MEMORANDUM

To: Kim Adamson and Taj Dufour, Soquel Creek Water District

From: Gus Yates and Iris Priestaf, Todd Groundwater

Re: Peer Review of Technical Water Resources Studies Prepared for Soquel Creek Water District—Final

May 2014	Figure 1 Rainfall Recharge in Semiarid Regions

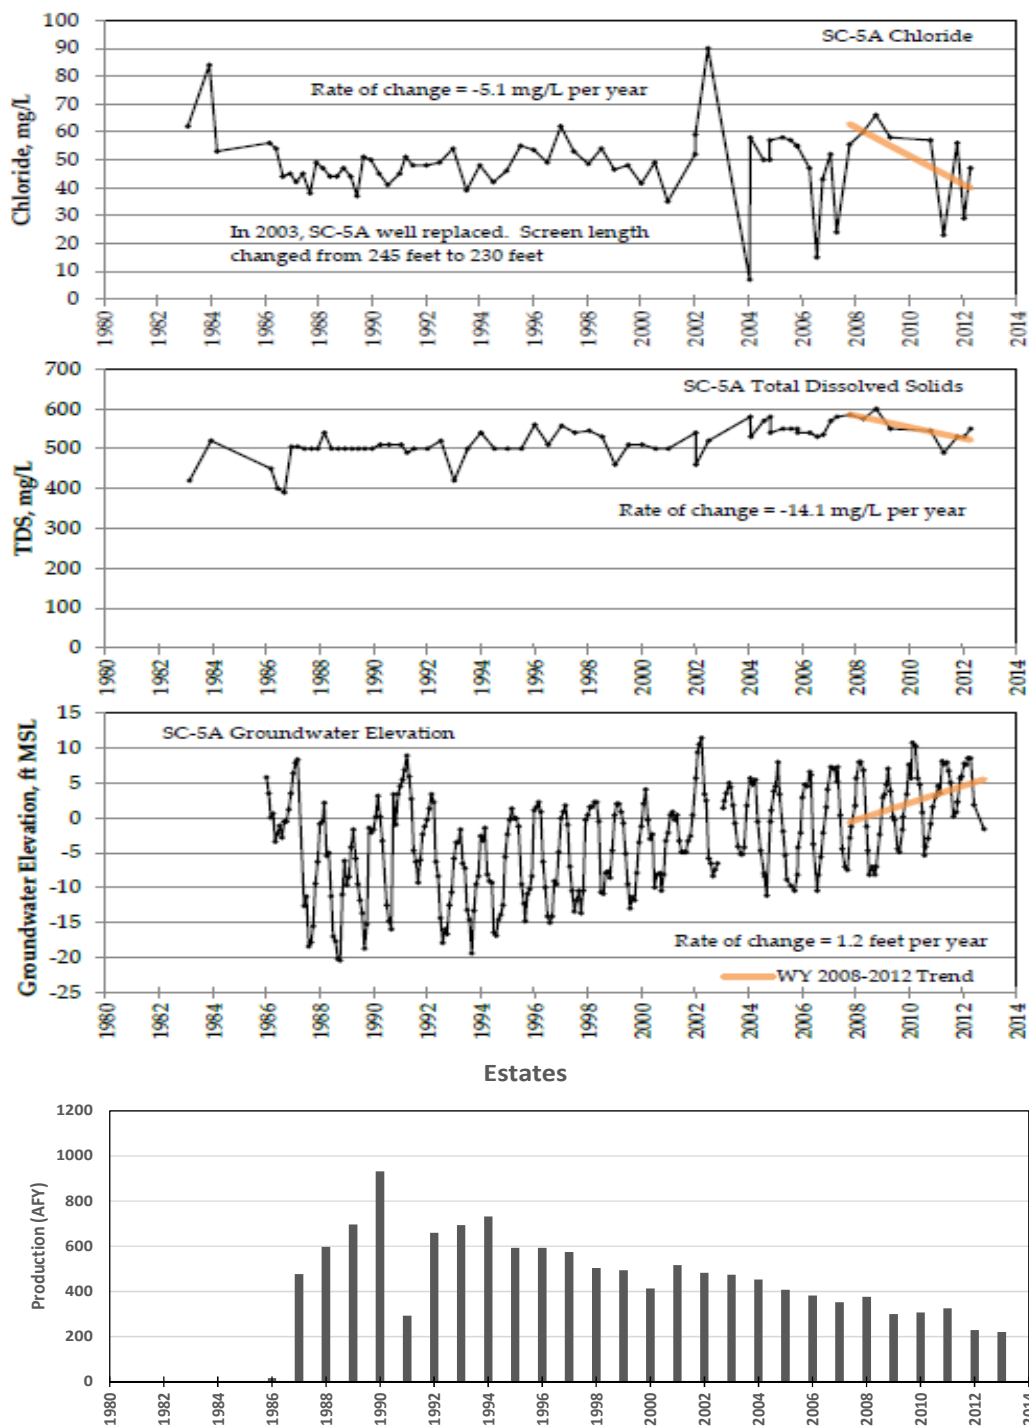
The plot of deep recharge versus annual precipitation (HydroMetrics WRI 2011, Figure 34) indicates that deep recharge does not commence until annual rainfall exceeds a threshold of about 16 inches/year. This is substantially higher than the threshold for typical semiarid regions. **Figure 1** shows the relationship of groundwater recharge and annual rainfall compiled from 30 studies of recharge in basins around the world (Bedinger, 1987). Data from the PRMS model are also shown, converted to an average one-dimensional flux over the 65-square-mile basin. The average threshold for initiating recharge was approximately 10 inches of annual rainfall. The discrepancy could stem from the conceptual differences between PRMS and the other studies. The other studies were mostly for basins where all percolation below the root zone becomes groundwater recharge. In PRMS, percolation below the root zone becomes shallow groundwater, some of which flows to streams. Only the remainder becomes deep recharge. The Soquel-Aptos PRMS model could be compared with the other studies by adding stream base flow to deep recharge.

Figure 2
Pumping, Water Levels and Water Quality at Well SC-5A

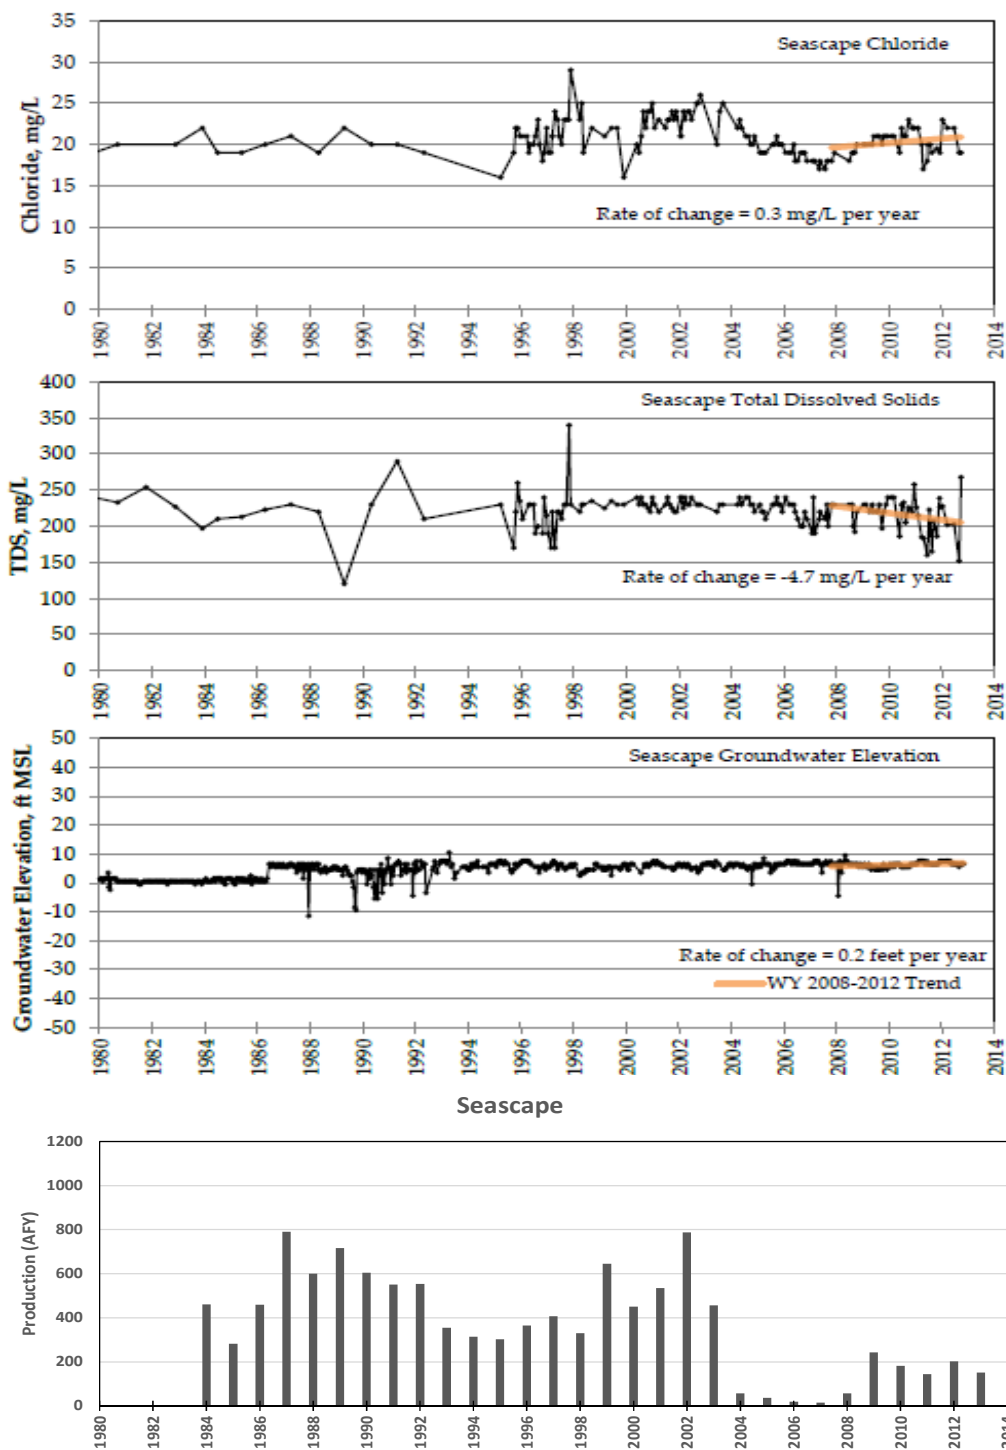
Figure 2 shows an example of a well where all three expected relationships are evident: periods of decreasing pumping at the Estates well correspond to periods of rising water levels at nearby coastal monitoring well SC-5A. As water levels rose, TDS and chloride both decreased. In contrast, **Figure 3** shows an example where none of the expected relationships were present. At the Seascape well, water levels in the production well appeared to be unaffected by pumping, and chloride and TDS had opposing trends that

were both inconsistent with water levels. The visual comparisons revealed that only 29 percent of the water-level hydrographs could be confidently correlated with pumping at a nearby well, with another 28 percent showing weak or intermittent correlation. Among wells within 3,000 feet of the coast, only 41 percent consistently showed increases in TDS and chloride correlated with decreases in water levels, and an additional 40 percent exhibited weak or intermittent correlation. TDS and chloride trends were more reliably correlated with each other; only 14 percent of the wells had conflicting trends. The most surprising result of the inventory was the low level of correlation between pumping at a municipal well and water level in that well. Only two out of sixteen wells showed a strong correlation, and there was no correlation at half of the wells.
